## Addendum No. 2

Reference: Mechanical/Electrical/Plumbing Upgrades – Miller Administration Building  
Weber State University – Ogden, Utah  
DFCM Project No. 14031810

## ADDENDUM #2

Project: Weber State University  
Miller Administration M.E.P. Upgrades  
3848 Harrison Boulevard  
Ogden, Utah 84401

**ME102**

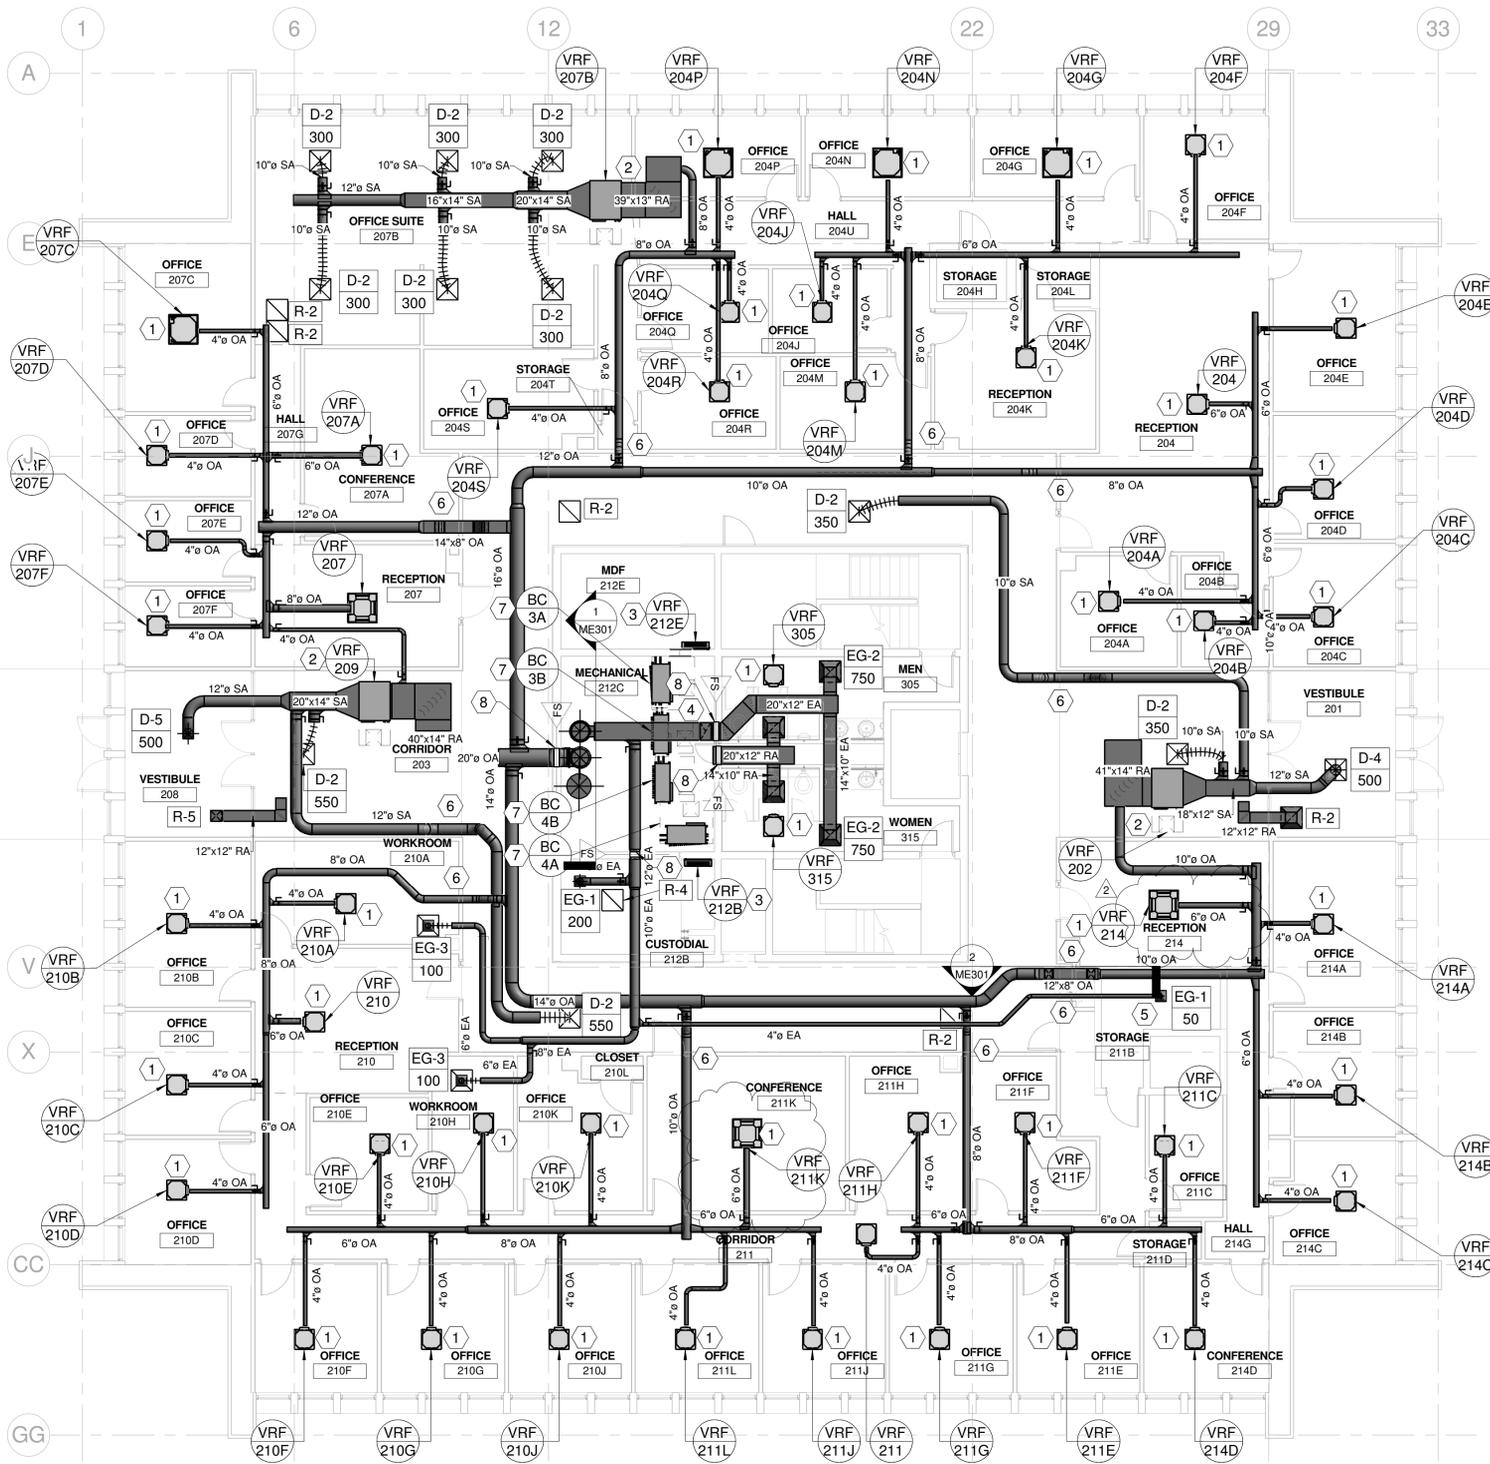
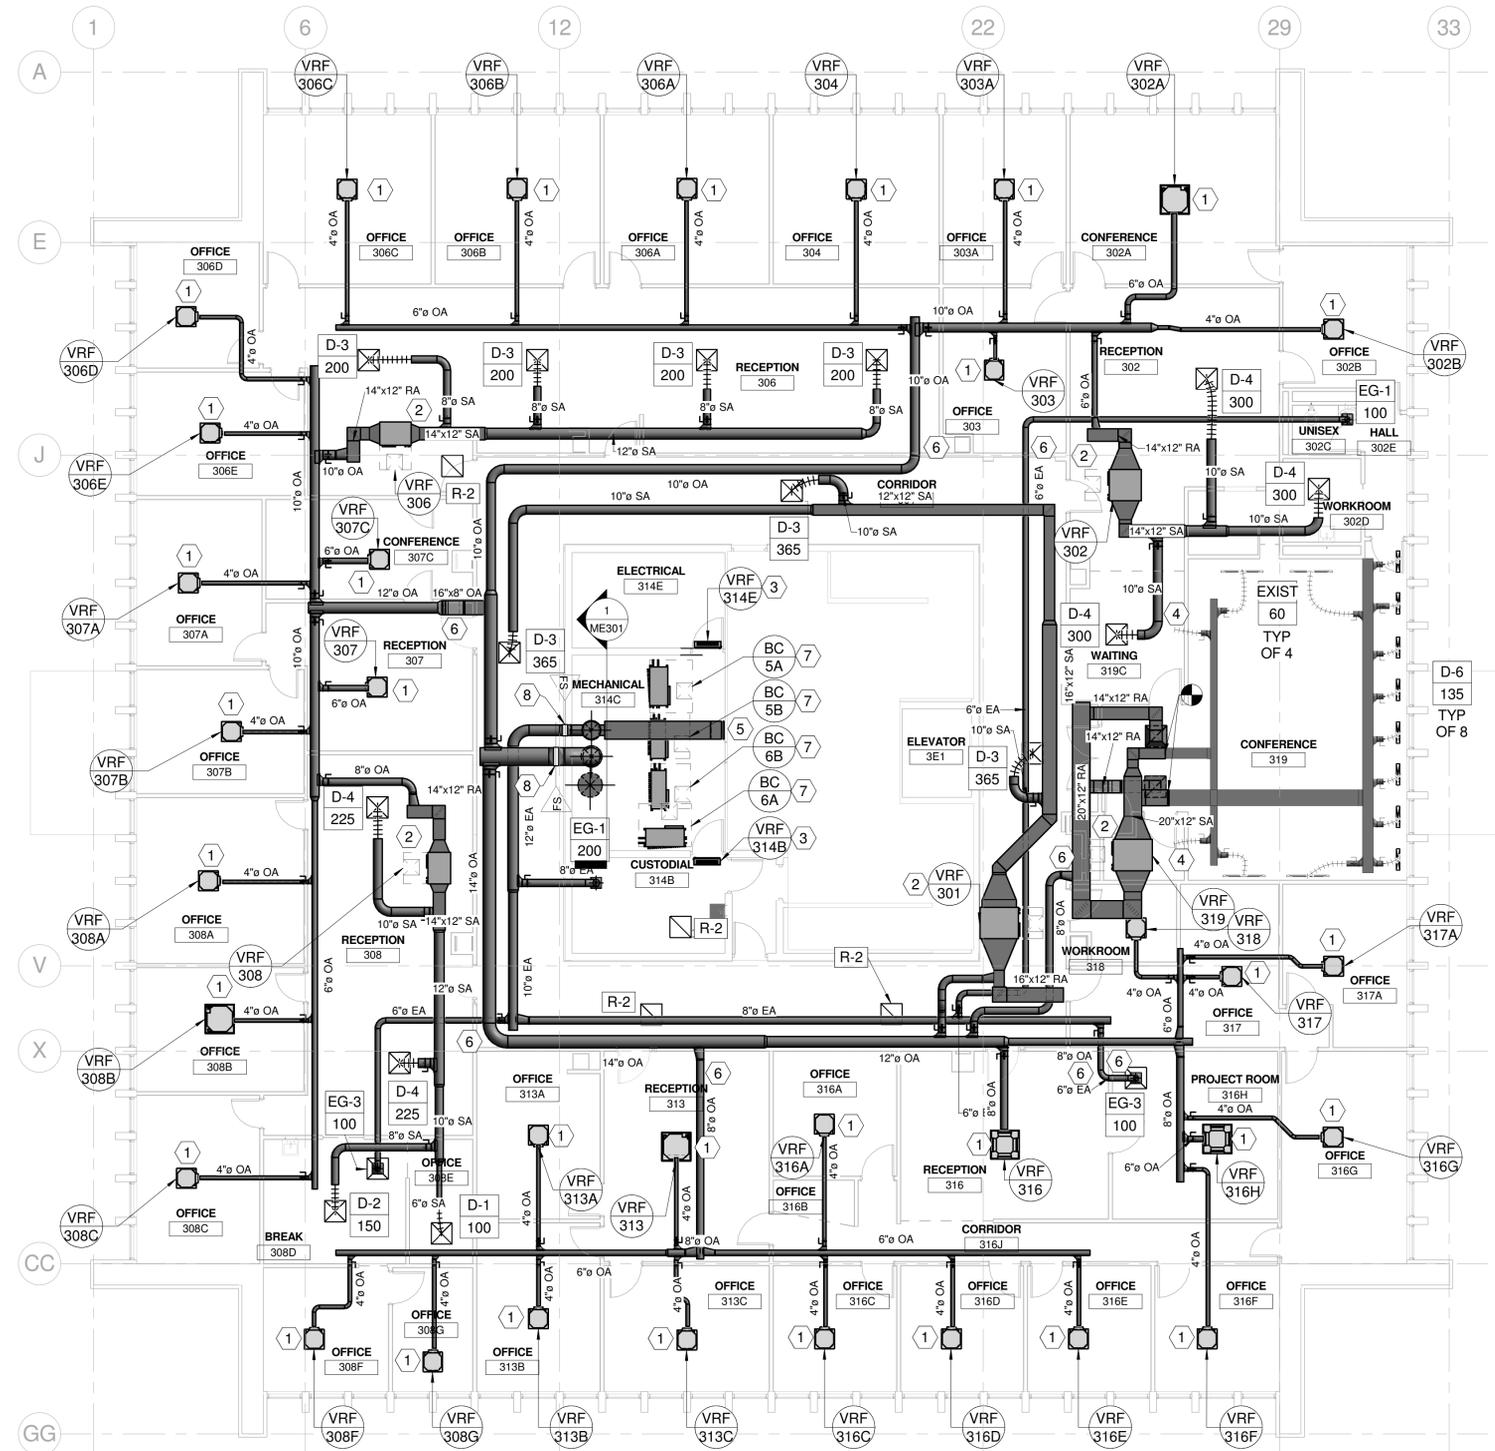
- Item II-1.** Modified the physical dimensions of a few indoor VRF units. See attached updated sheets ME102, ME103, ME602, and ME603.
- Item II-2.** Added note that ERV needs to be disassembled to fit through a standard man door then reassembled in the mechanical room. See attached updated sheets ME401 and ME601.

**ME603**

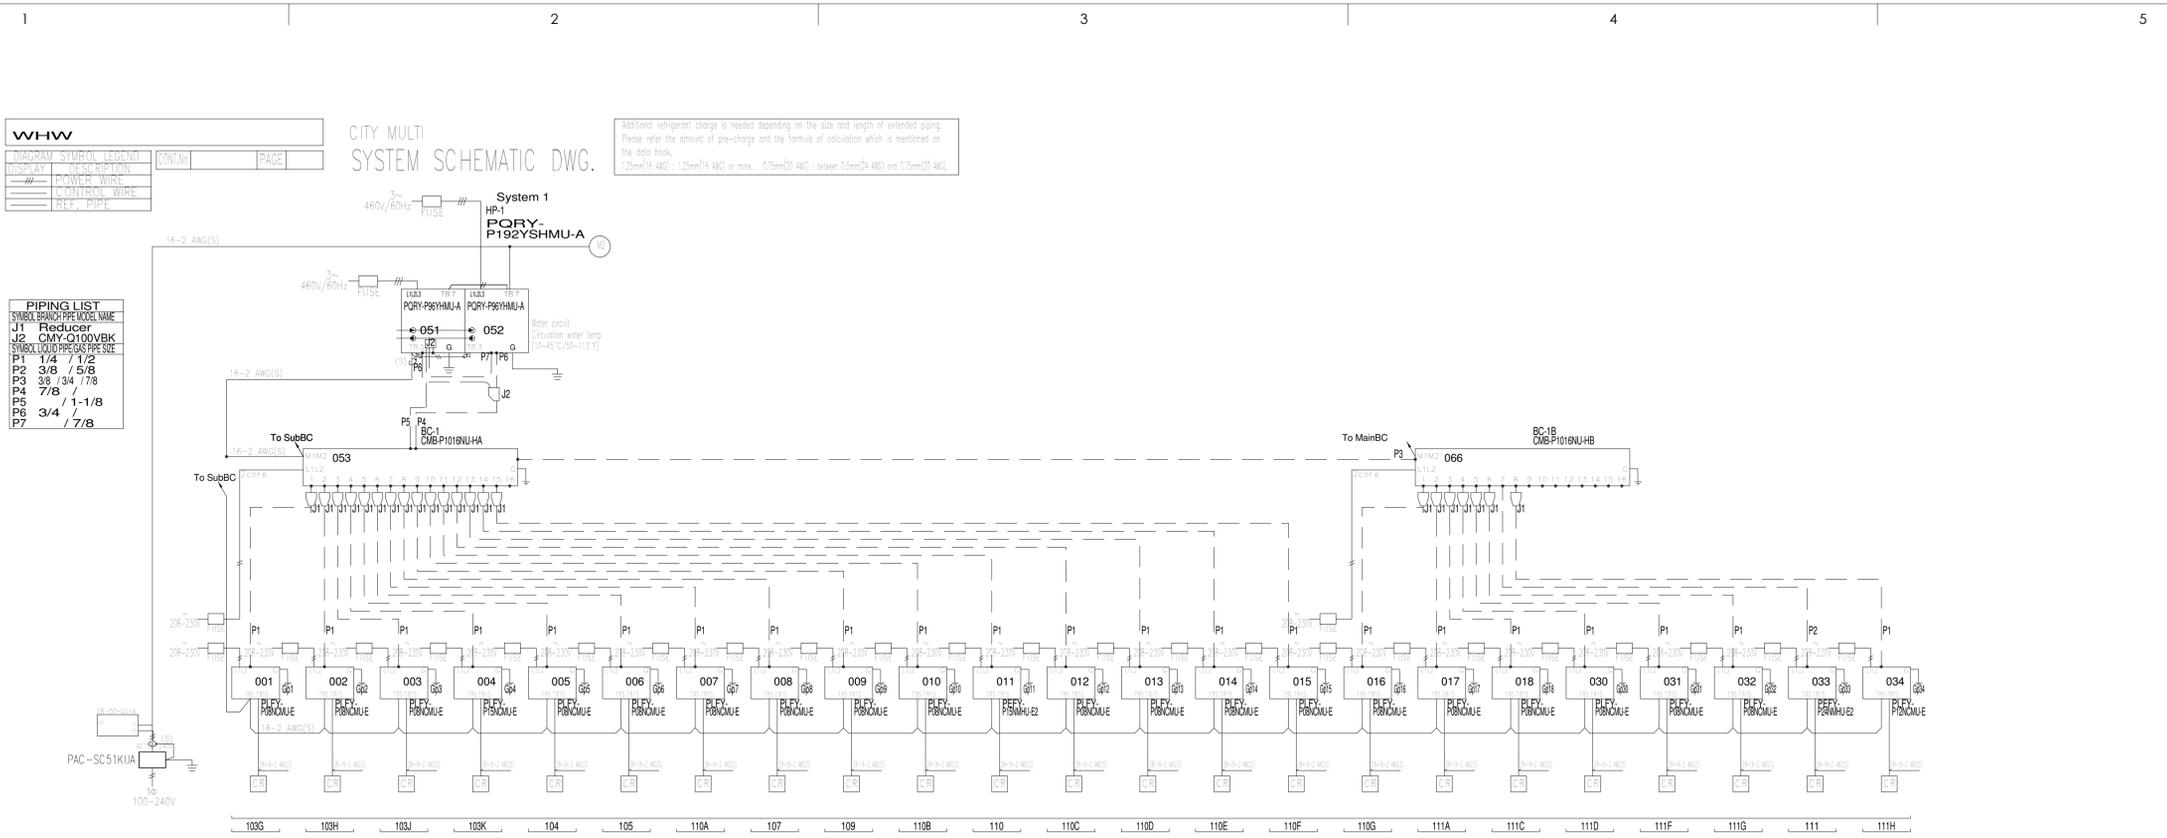
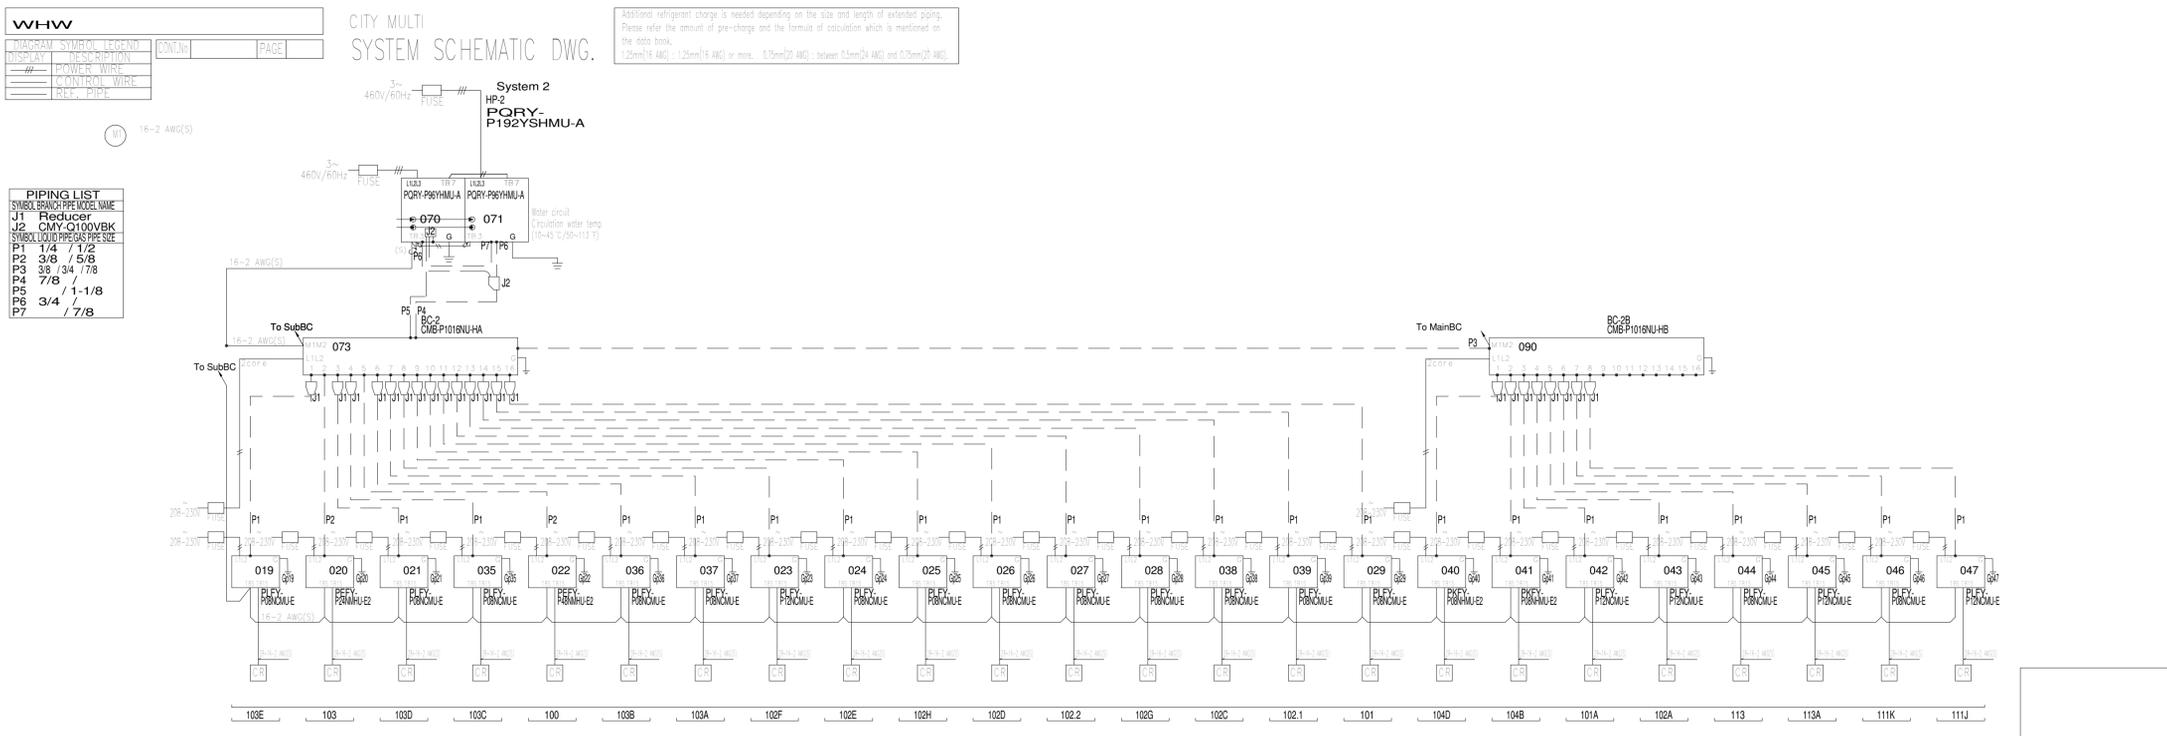
- Item II-3.** Added a note to provide multifunction casements on indoor ceiling cassettes requiring 75 CFM or more of outside air. See attached updated sheets ME602 and ME603.

- Item II-4.** Added a note on sizing the refrigerant piping for the VRF systems to the schedules. See attached updated ME602 and ME603.
- Item II-5.** Updated the VRF Schematics and made them more readable. See attached updated ME902, ME903, and ME904.
